REPORT FOR
GREENBRIER ESTATES
TORRINGTON, CONNECTICUT

Environmental Review Team Report

Torrington Inland Wetlands Commission

DECEMBER 1987

Figure 2

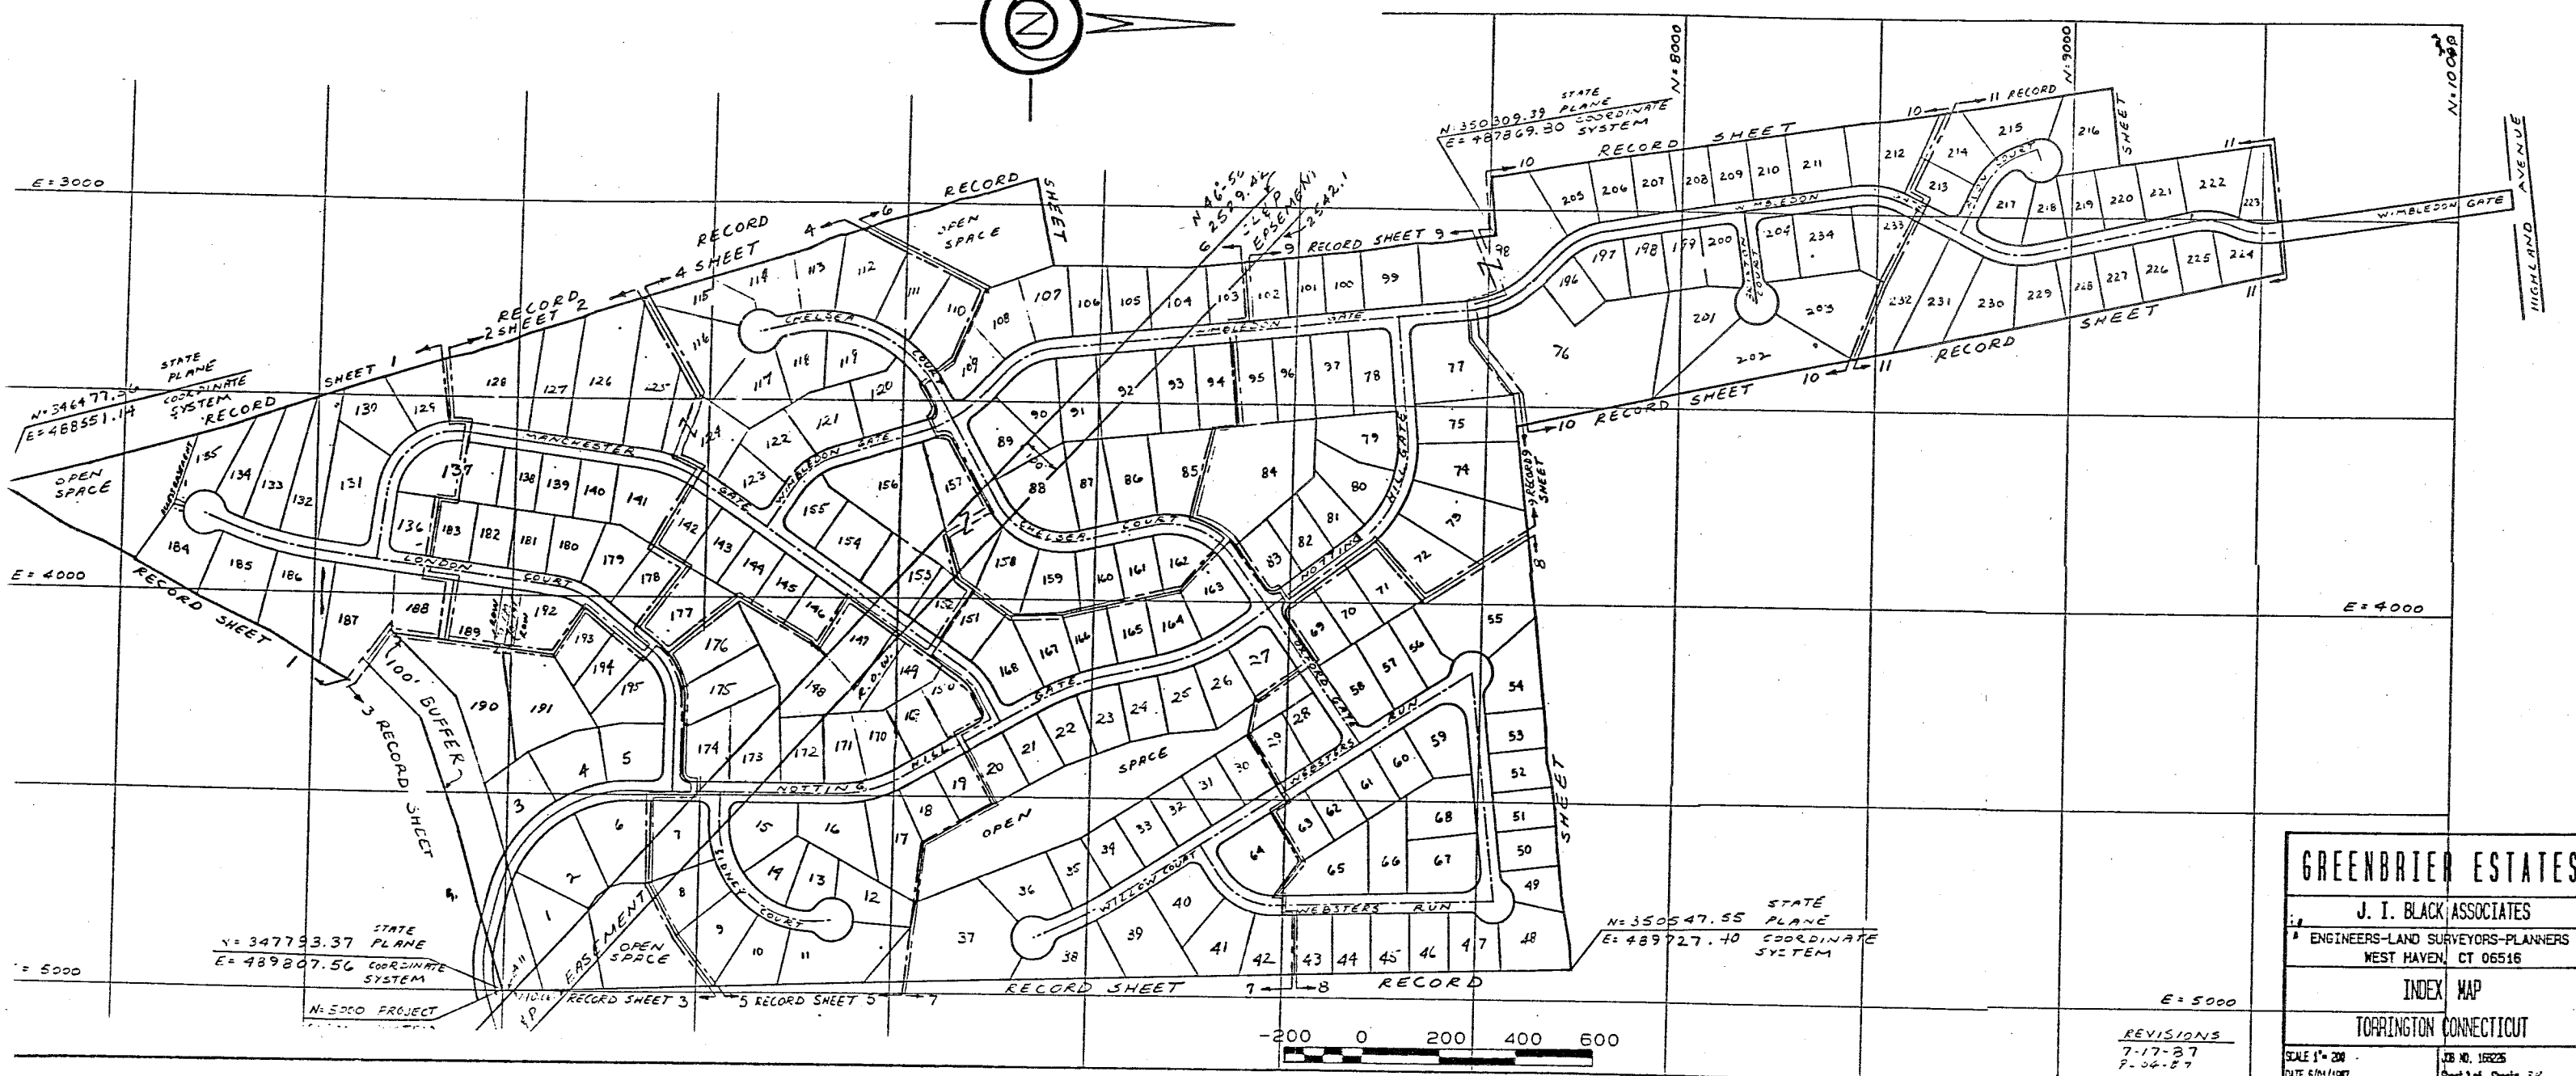
Based on the subdivision plan on display during the prereview meeting, several road crossings of the wetlands are proposed. It is estimated that a total of 1337 feet of wetlands will need to be crossed. As discussed during the pre-review meeting, there appears to be some flexibility for the realignment of roads, which would result in less of an impact on the wetlands within the site. It is strongly suggested that these alternative routes be considered. In some cases, certain lots may need to be eliminated.

Wetland road crossings can be feasible, provided they are properly engineered. Provisions should be made for removing unstable material beneath the roadbed, backfilling with a permeable road base fill material, and installing culverts as necessary. When crossing any wetland, the road should be at at least 1.5 and preferably 2 feet above the surface elevation of the wetlands. This will allow for better drainage of the roads. It will also decrease the frost heaving and should be done at a dry time of the year. Provisions should include an effective erosion and sediment control plan.

Figure 7

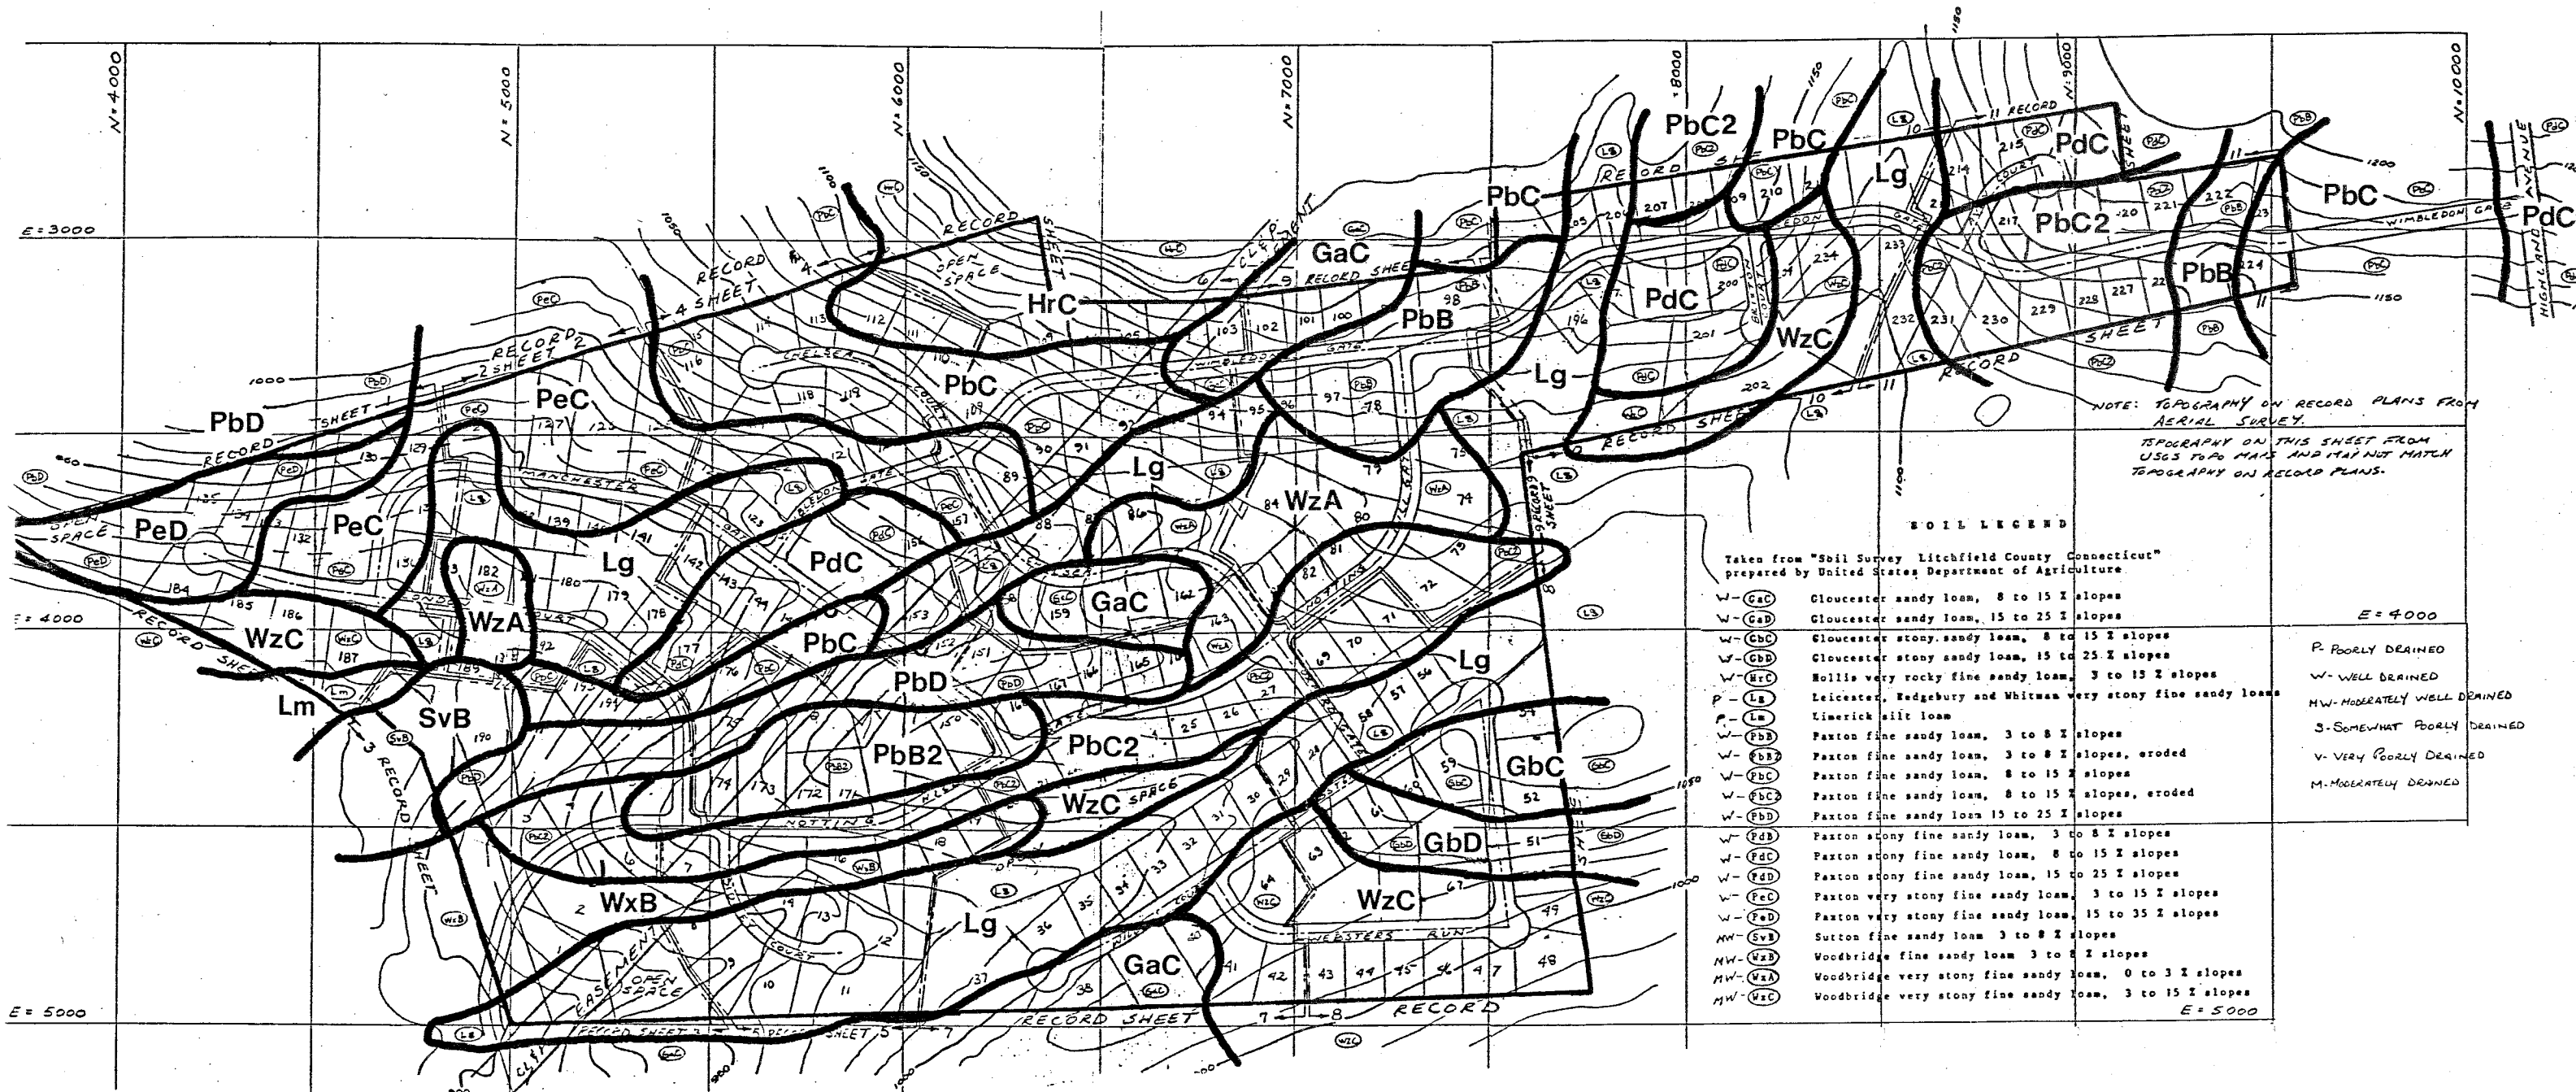
The wetlands flagging and scale of mapping are at a scale adequate for subdivision and lot planning. No map legend is shown on the subdivision record maps, but a legend is needed to clarify all wetland boundaries. For the purposes of the Environmental Review Team report it was assumed that the dashed line with triangles represents the flagged wetland boundary and the solid line with triangles represents the areas where the soil survey map was different than the flagged boundaries.
